ArcGIS Web Map

Doemel, Robert

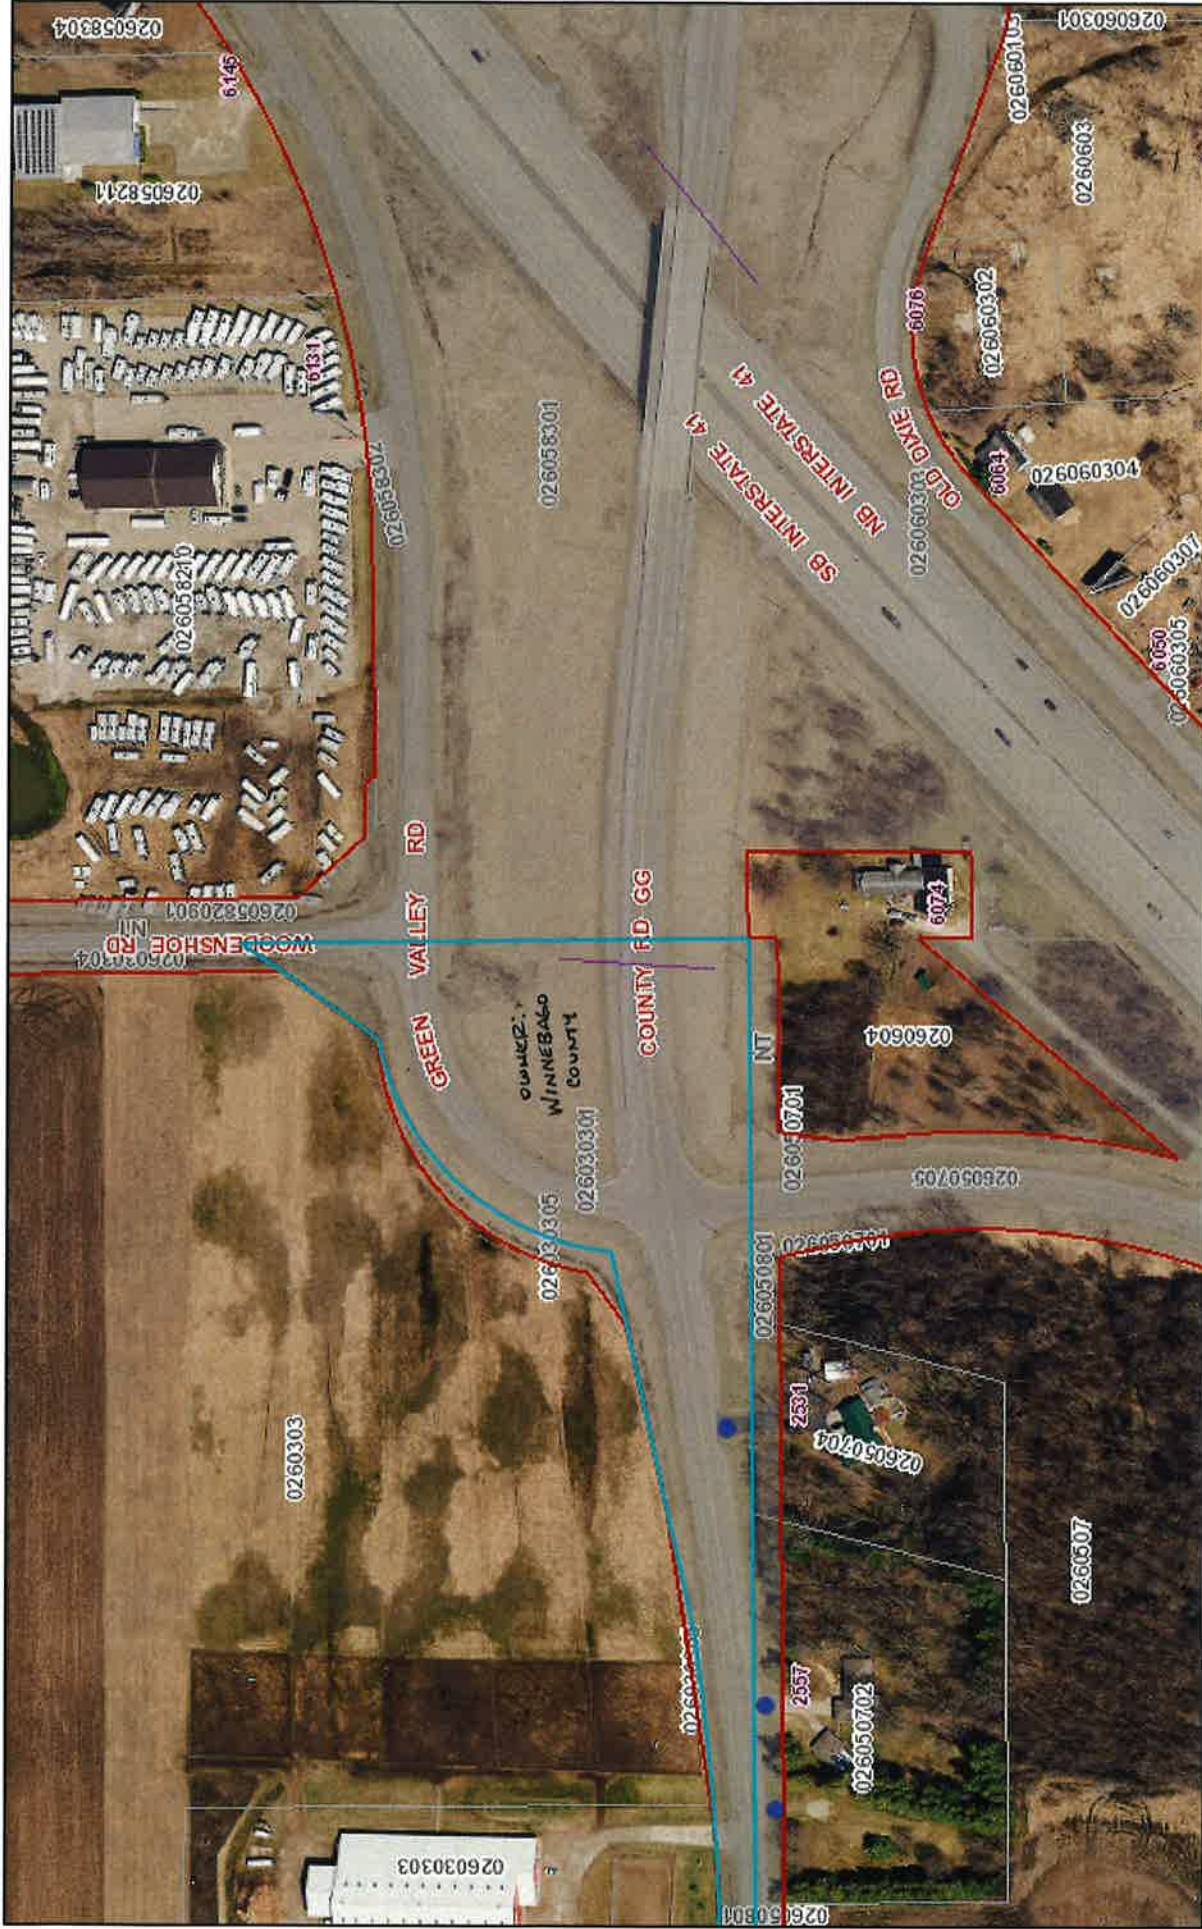
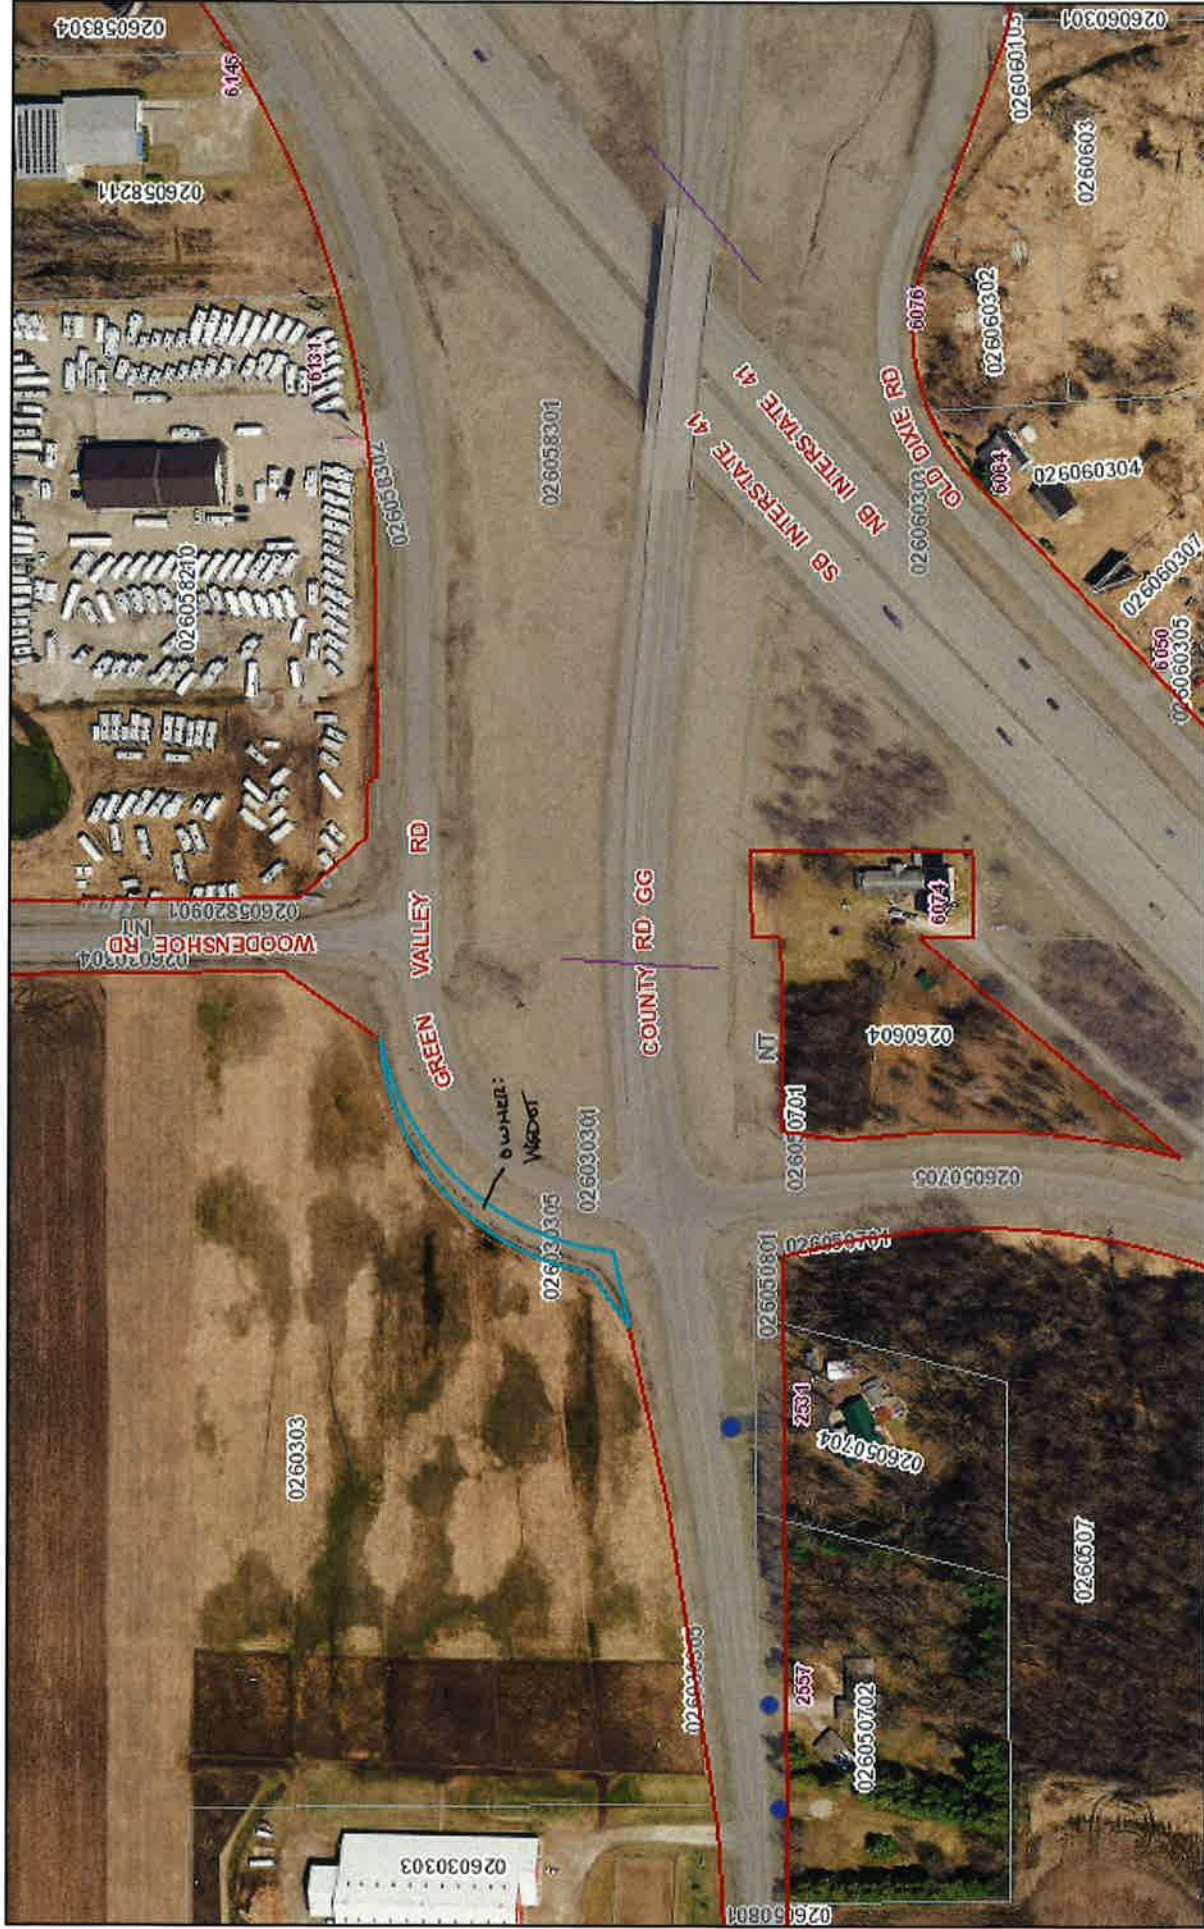
What I am seeing is we had a construction project that flattened the slopes off the ramps and eliminating the need for the beam guard. Please keep in mind that beam guard in itself is a hazard, and should only be installed when the hazard you are protecting is greater than the hazard of the beam guard.
